K-1786
PATENT

In re Application of OJANEN)
Serial No. 09/838,348) Group Art Unit 3673
Filed: April 19, 2001)
For: ROTATABLE CUTTING TOOL) Examiner: Singh, Sunil
HAVING RETAINER WITH DIMPLES)

Sir: APPEAL BRIEF UNDER 37 CFR §41.37

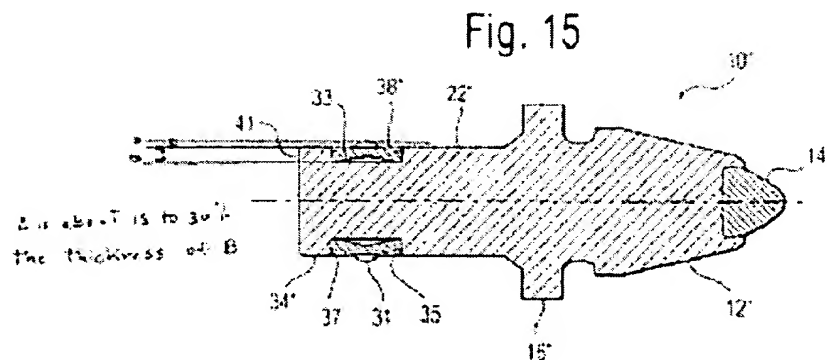
Per Paragraphs 2 and 3 of the February 8, 2007 final Office Action, the Primary Examiner rejected claims 15-17, 29-30, 32-40 and 43-47 under 35 USC §102(e) as being anticipated by the '652 Sollami patent. In short, the Examiner stated that all of the limitations of the claims exist in the '652 Sollami Patent, and in doing so, referred to a marked-up copy of FIG. 15 of the '652 Sollami Patent. A reproduction of the Examiner's

In addressing the numerical range as set forth in the claims, the Examiner used the ‘652 Sollami Patent and wrote, “... the amount of radial projection of said protruding surface beyond the cylindrical surface of the retainer is between about 15 percent and about 30 percent of the thickness dimension of said retainer (see attached marked up Fig. 15).” See

First, the radial projection of the dimples of the retainer in FIG. 15 of the '652 Sollami Patent is much greater than the claim recitation of 15-30%. In the October 5, 2005 Appeal Brief in this patent application and using Appeal Exhibit 4 therefrom as support, appellant argued that the protrusion projected in the radial outward direction a distance equal to about 88.9% of the thickness of the retainer. While applicant does not retract that argument, applicant points out that more recent measurements using an enlarged (200%) copy of FIG. 15 from the USPTO website projected from a transparency on a screen (measurements taken from the image on the screen) reveals different values for the radial outward projection of the protrusion. These values are 78% when compared against the thickness of the retainer at the location of the protrusion and 64% when compared against the thickness of the retainer at the distal edge of the retainer. Appellant submits that both of these measurements (i.e., 64% and 78%) are significantly greater than the 15-30% of the claims. Thus, the Primary Examiner is in error to argue that FIG. 15 of the '652 Sollami Patent addresses the claims.

Appellant disagrees with the Primary Examiner's position because the claims call for the dimples to protrude from the retainer surface to a much lesser extent (i.e., 15-30%) than in the '652 Sollami Patent, as well as all of the prior art applied at one time or another during this prosecution².

FIG. 15 is set forth above. This is in contrast to a drawing such as FIG. 5 of U.S. Patent No. 4,484,783 to Emmerich (of record in this case) shows both the retainer body and dimple in cross-section.

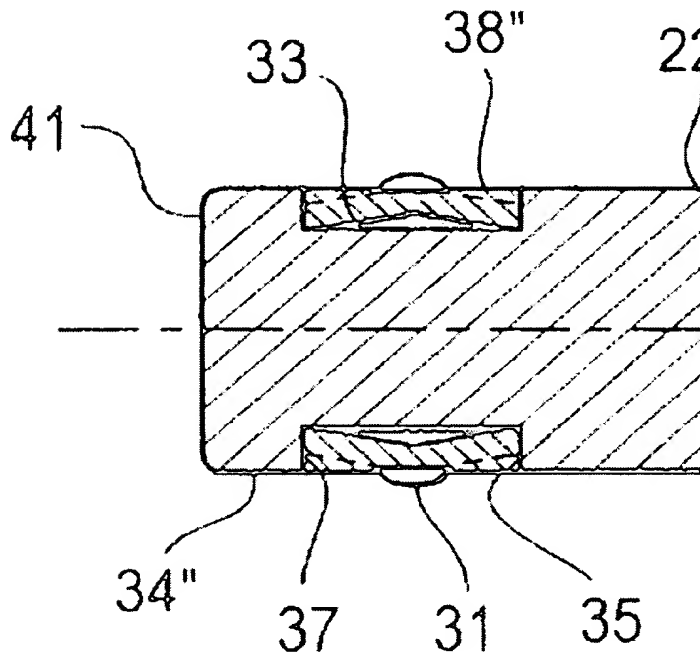
Second, a careful review reveals that FIG. 15 illustrates the retainer body in cross-section and the protrusion (31) is not in cross-section. In this regard, a reproduction of

Basic drafting principles establish that since the protrusion (31) of FIG. 15 is not shown in cross-section, it must be rotated away from the section line. What this means is that the extent of the radial outward projection of protrusion is actually greater than what FIG. 15 shows. Since there is no description as to the extent of the rotation, there is no way to accurately determine the extent of the radial outward projection. This is a fundamental flaw in the Primary Examiner's use of FIG. 15 from Sollami.³

³ Since the protrusion of FIG. 15 is rotated away from the section line, the extent of the radial outward projection of protrusion is actually greater than what is shown in FIG. 15, and hence, more strongly supports appellant's argument that the '652 Sollami Patent cannot address the 15-30% claim limitation of the pending claims.

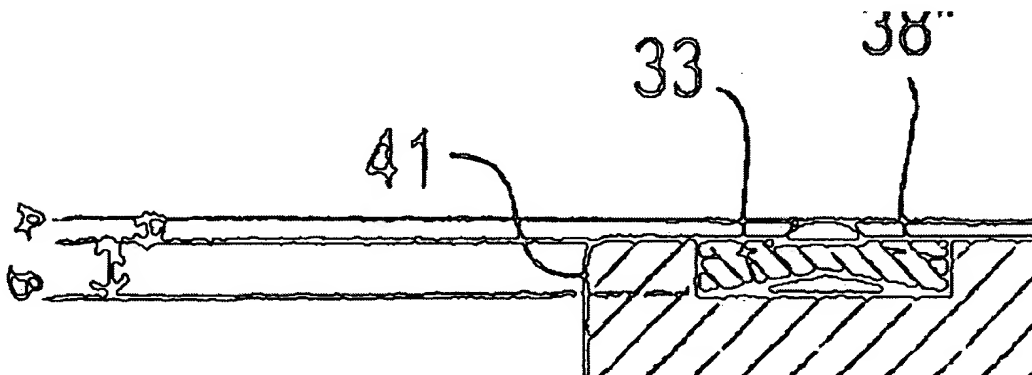
Further, a careful look at an enlarged version of FIG. 15 shows that the retainer sleeve (38") is somewhat arcuate and is of a generally constant thickness. The fact that retainer sleeve 38" is of a generally constant thickness is consistent with the illustrations of sleeves 38 and 38' in FIGS. 3 and 3A, as well as the broken lines of each surface of the retainer shows that retainer sleeve 38" is of a generally consistent thickness. An enlarged view of the rear portion of the tool (10") of FIG. 15 establishes that the thickness is generally consistent.

As shown by the enlargement of the Primary Examiner's marked-up copy of FIG. 15 (see below), the Primary Examiner takes a measurement such that the thickness of

the retainer (dimension "b" in the attachment to the Office Action) is equal to the depth of the groove (33).⁴ This is inconsistent with the drawing that shows broken lines as representing the surface of the retainer. To the extent that a measurement of the thickness of the retainer is proper, a measurement of the thickness dimension "b" should be taken to correspond to the thickness of the retainer as shown by the broken lines and not to the depth of the groove.

⁴ If a retainer has a thickness equal to the depth of the groove, the retainer would not have the ability to retract and then expand wherein the protrusion engages the interior channel in the bore of the holder.
